Info Only: Engineering
comments are in blue
text.

**PRELIMINARY DRAINAGE REPORT
FOR
URBAN LANDING
PRELIMINARY PLAN**

Job No. 1308.01 PUDSP243
PCD File No. ←

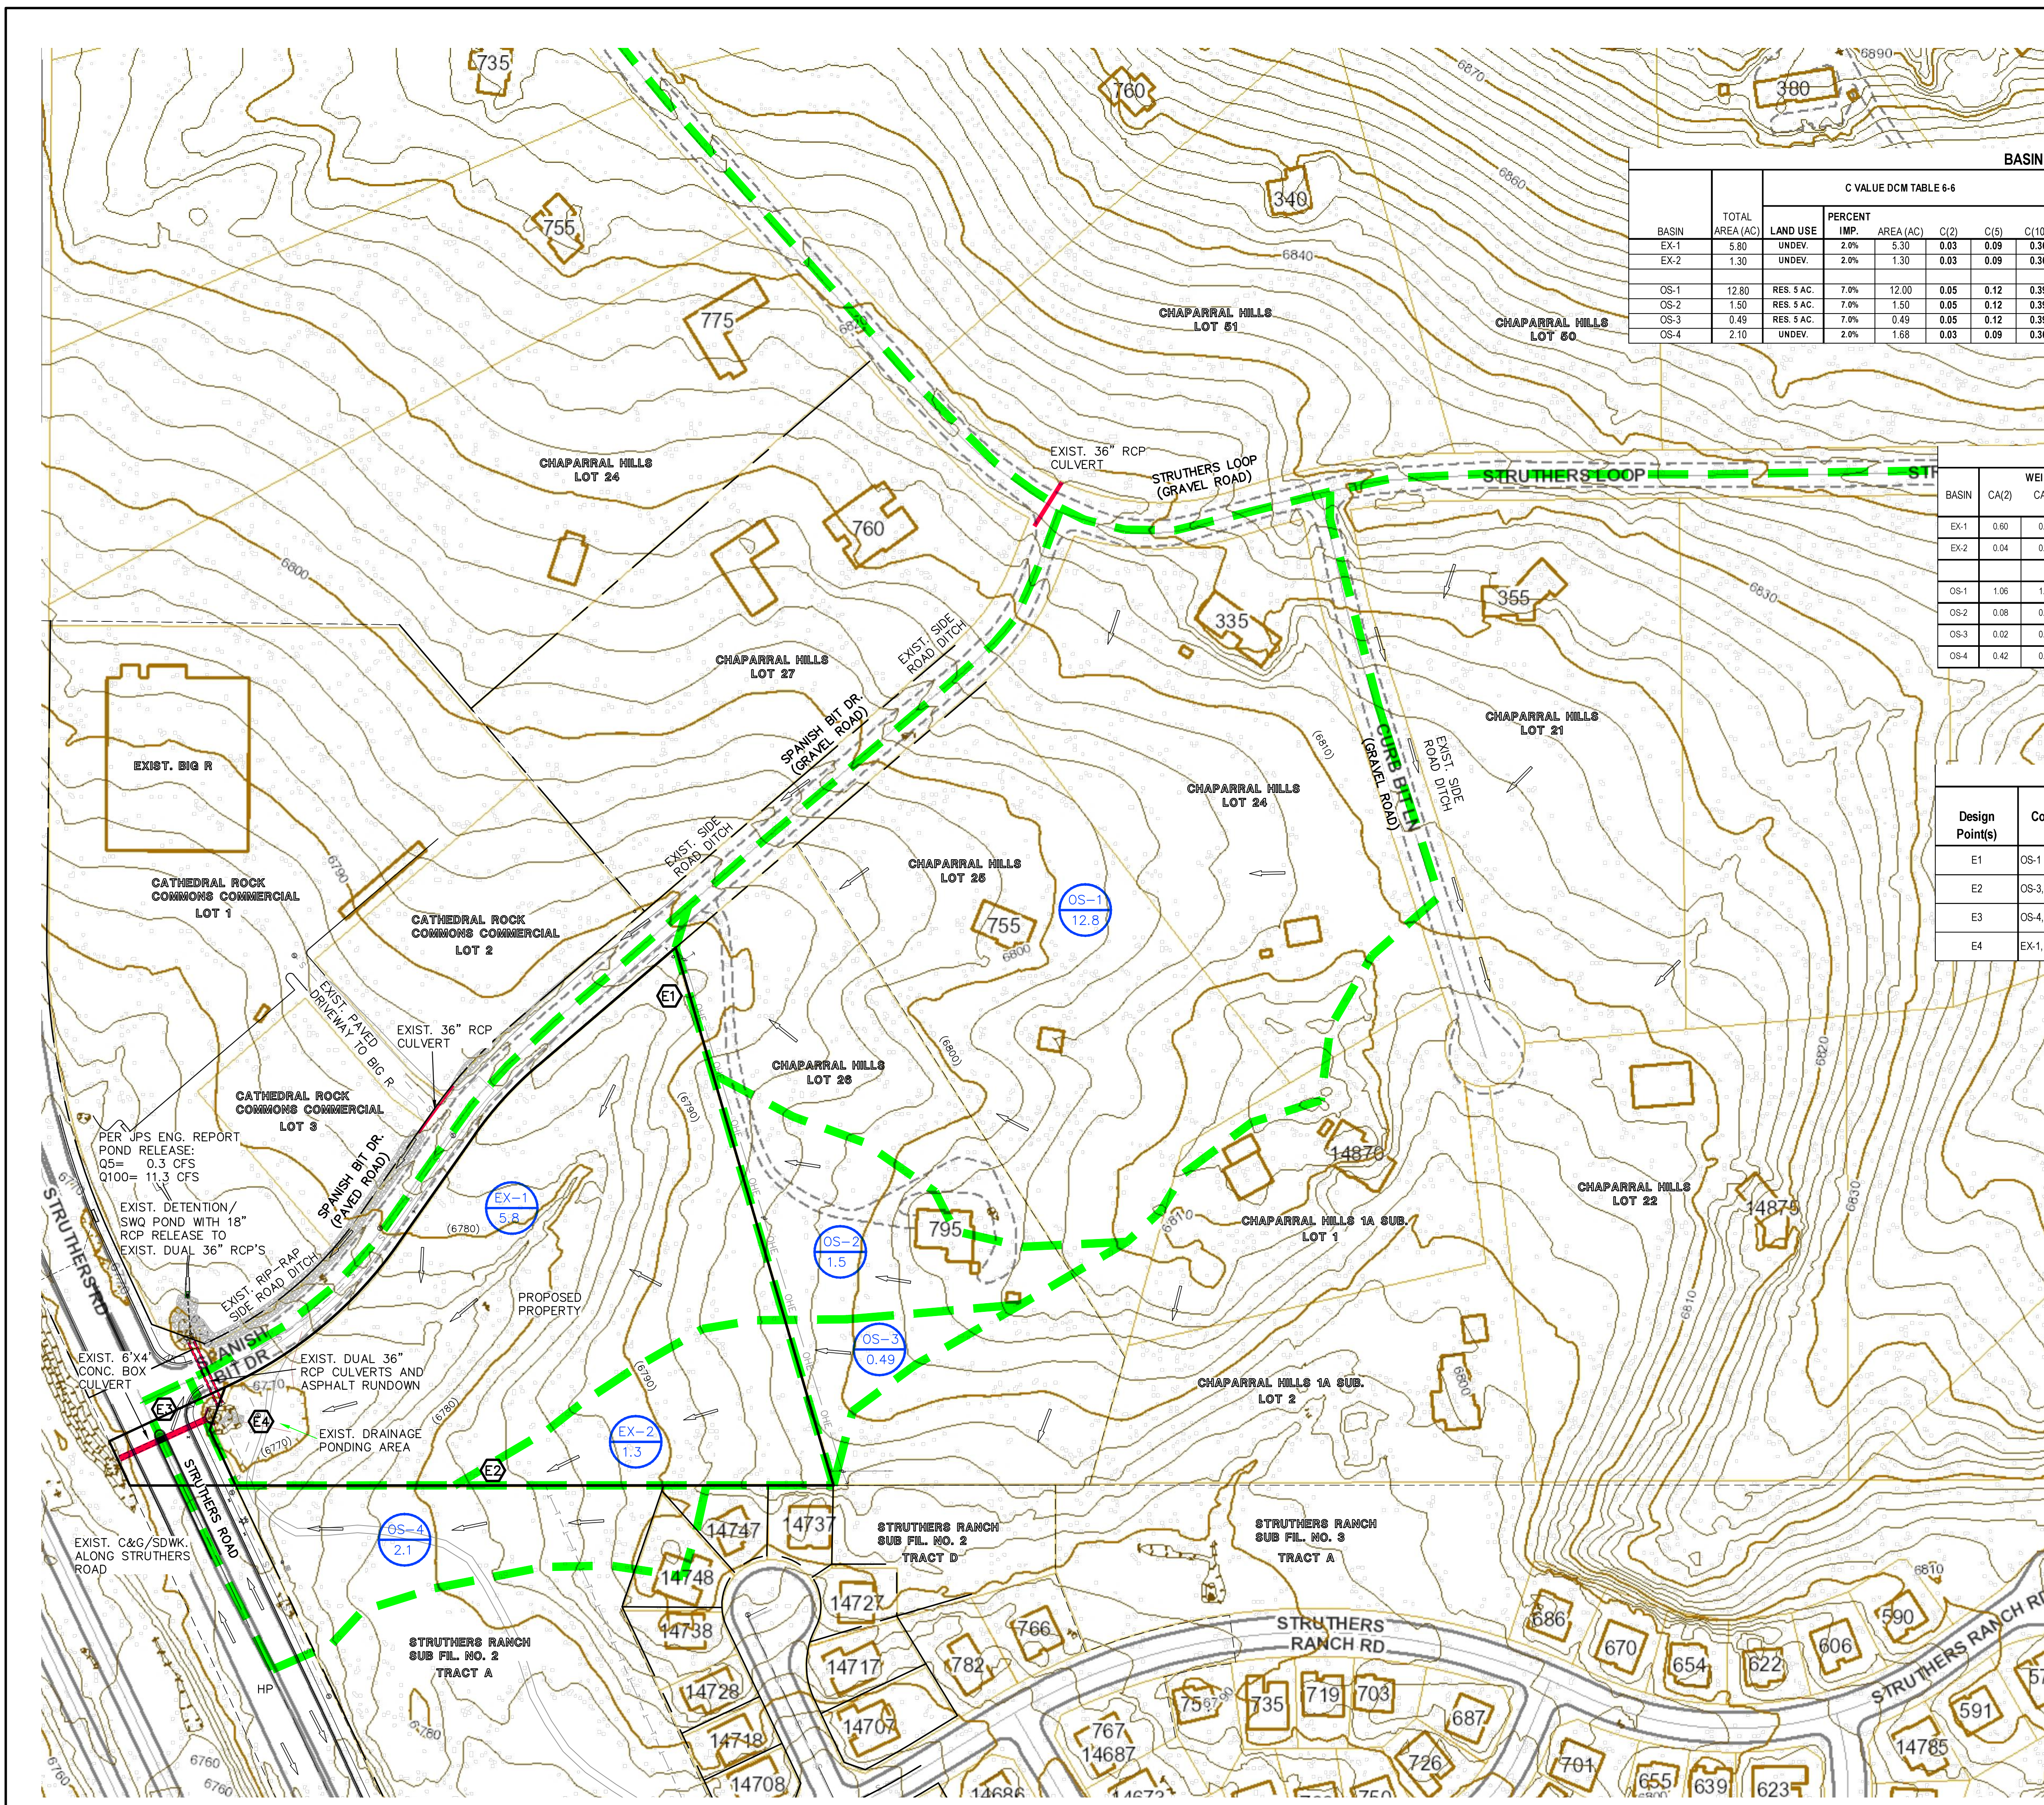
Also, indicate how flow will rundown. curb chase indicated on prelim. plan

Provide a design point at this pond inflow point so we know whether or not a forebay is needed and what size riprap for the rundown.

Concentrated flow from the proposed swale cannot
 be discharged directly into the proposed pond.
 Please provide a riprap rundown.

Overland length for urban area cannot be greater than 100ft. Please revise.

Overland length for urban area cannot be greater than 100ft. Please revise.

Please expand the map to show outfall discharge. Please display the off-site contour 50 feet beyond the outfall pipe illustrate how the runoff diverges from the site.

Please show all drainage easements
